Subject: Byron Generating Station Units 1 and 2  
Braidwood Generating Station Units 1 and 2  
Power Operational Relief Valves  
NRC Docket Nos. 50-454, 50-455, 50-456,  
and 50-457

This is to provide additional information regarding the use of power operated relief valves (PORV's) for venting and depressurizing the reactor coolant systems at Byron and Braidwood stations. Enclosed with this letter is the response to FSAR question 212.159 which was transmitted in reference (a). This response will be incorporated into the Byron/Braidwood FSAR in a future amendment.

Question 212.159 (a) Use of PORV's as Pressurizer Vents

Figure 1  
Loop Reflux Illustration

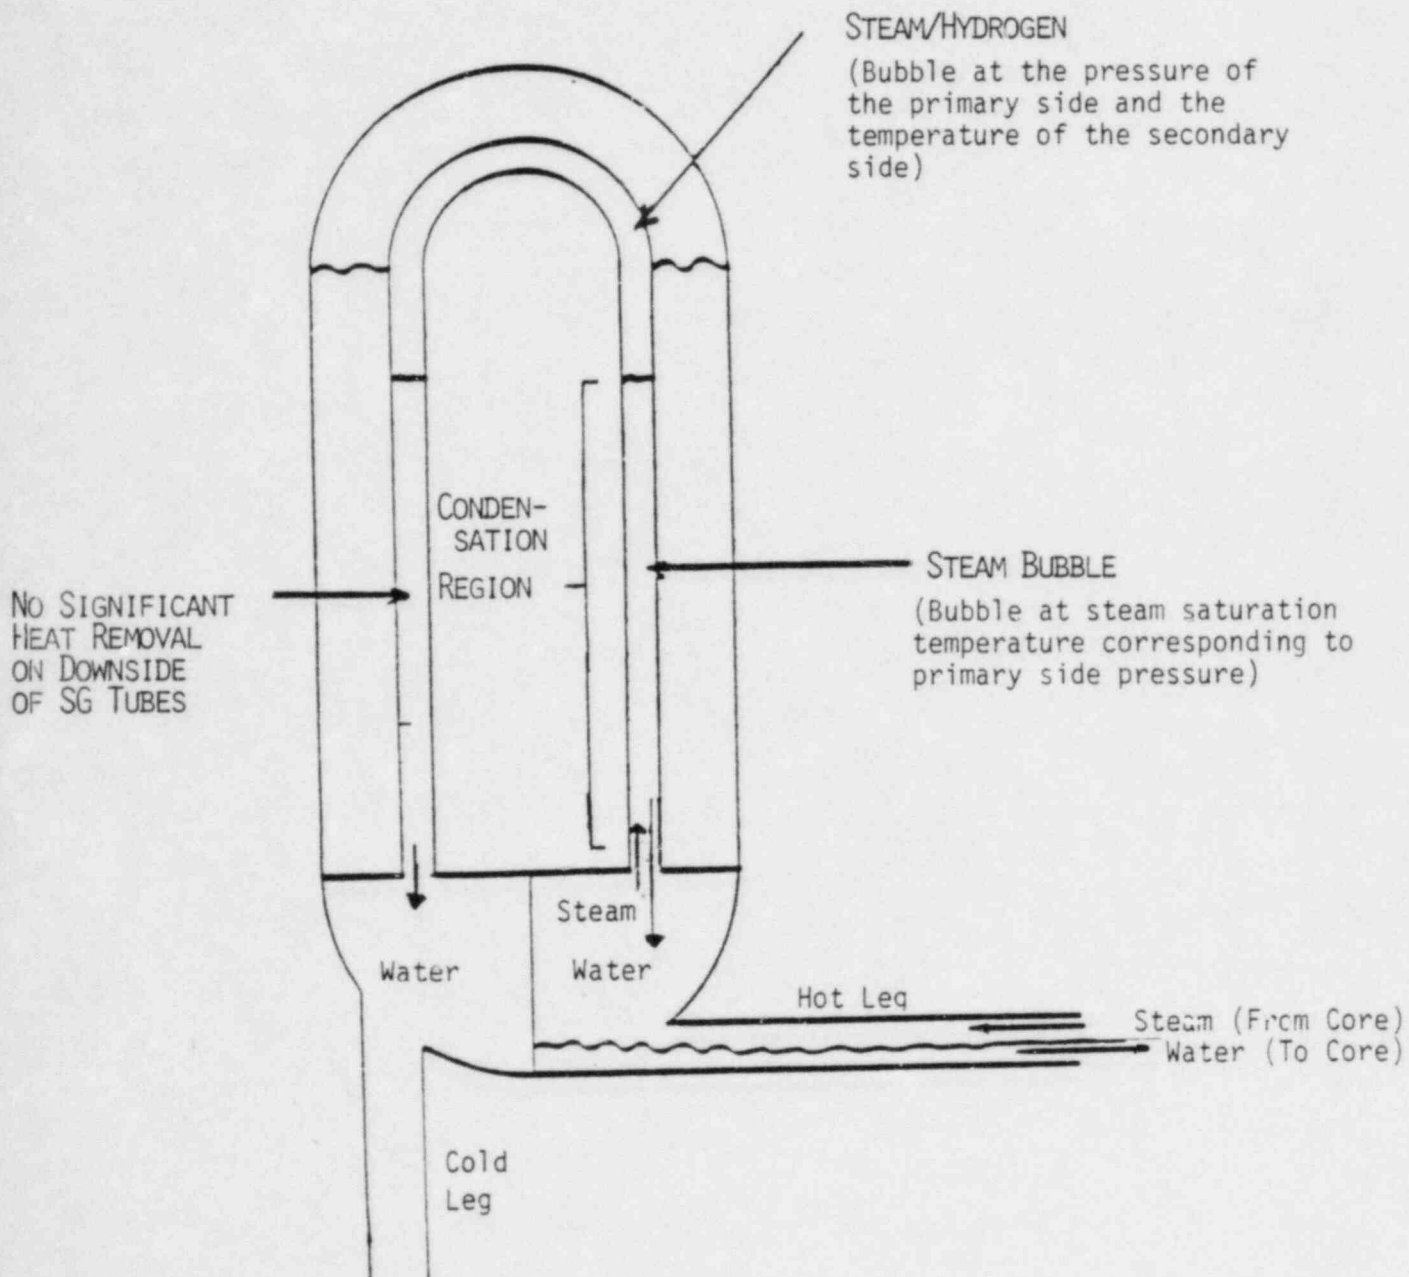
In your response to TMI Action Item II.B.1 in the Byron/Braidwood FSAR Appendix E.19, you did not address venting of the pressurizer. In recent discussions with CEC, the staff understands that you plan to take credit for use of the PORV's as vents. The requirement for venting the pressurizer is addressed in 10 CFR 50.44(c)(3)(iii) which requires venting of high points in the RCS. The requirement states that the high point vents must conform to Appendices A and B of 10 CFR Part 50, which includes GDC 2 "Design Bases for Protection Against Natural Phenomena" and GDC 4 "Environmental and Missile Design Bases." Because use of the vents is anticipated only for very severe accidents, venting systems should be designed for the Safe Shutdown Earthquake and harsh environments.

Describe how the current pressurizer vent system of PORV's, block valves and their associated operators meets the requirements for environmental and seismic qualification, or provide a system which will meet these requirements.

The first situation is illustrated in Figure 1. Masses of hydrogen corresponding to various amounts of zirconium water reactions have been assumed to form a discrete bubble in the steam generator. These amounts of hydrogen obviously represent some fraction of the total hydrogen which could have been generated in some postulated severe accident. This fraction is probably far less than one, and in fact hydrogen masses corresponding to 50 percent zirconium water reaction maybe actually physically unrealizable given the fact that as the accident occurs steam and hydrogen relief will occur thus limiting the amount of hydrogen present in the primary system at the recovery time. Certainly assuming that all of the hydrogen is present in the steam generator represents a significant conservatism. The bubble is at pressure equilibrium with the primary system, but in thermal equilibrium with the secondary side. It is also conservatively assumed that this bubble blocks the loop flow and thus the only mode of heat transfer is the reflux method illustrated in Figure 1, and thus only half of the tube surface is available for condensation.

The method of analysis for the case of a separate hydrogen bubble forming in the tops of the steam generator U-tubes was as follows. First the volume of the steam generator taken up by the hydrogen bubble was determined based on the ideal gas law and the assumption that the hydrogen bubble temperature was the same as the secondary side saturation temperature. (This methodology is consistent with assuming no heat transfer from the bubble.) The required heat transfer coefficient was then determined based on the heat transfer area available in the steam generator, and a conservative decay heat at 1000 seconds. (Note that calculations indicate that for this limiting case using a decay heat value corresponding to 1000 seconds is very conservative.) The analysis was performed for a range of primary system pressures from 2500 psia to 400 psia, for a range of percent cladding reaction, and for the case of a pressurized secondary side (steam generator at its safety valve setpoint) and a depressurized secondary side. The required heat transfer coefficient for the two cases, pressurized secondary side and depressurized secondary side, is plotted in Figures 2 and 3 respectively as a function of primary system pressure at which the system could stabilize and the percent clad reacted. These graphs can be used to identify the pressure at which the primary system stabilizes at following an accident which generates a given amount of hydrogen, once the expected heat transfer coefficient has been quantified. If this pressure is below the primary system's safety valve setpoint (i.e., about 2500 psia) the plant will not continue to lose inventory and the plant is in a safe stable condition. Figure 2 shows that if the secondary side is at its safety valve setpoint (i.e., about 1200 PSIA) for 5, 10 and 20 percent clad reaction the primary system will stabilize at 2500 psia or less given that the heat transfer coefficient from the primary or secondary side is 28, 35, or 80 BTu/Hr/Ft<sup>2</sup>-°F or greater respectively. Similarly Figure 3 shows that if the secondary side has been depressurized to about atmospheric conditions (i.e., by using the safety grade atmospheric dump system) then for Zirconium water reaction of 5, 10, 20, 30, and 50 percent, the primary system will stabilize at 2500 psia or less given that the heat transfer coefficient from primary to secondary is 5.6, 6. , 7. , 8.0, and 12. BTu/Hr-Ft<sup>2</sup>-°F or greater respectively. These required heat transfer coefficients are significantly below those expected for this situation.
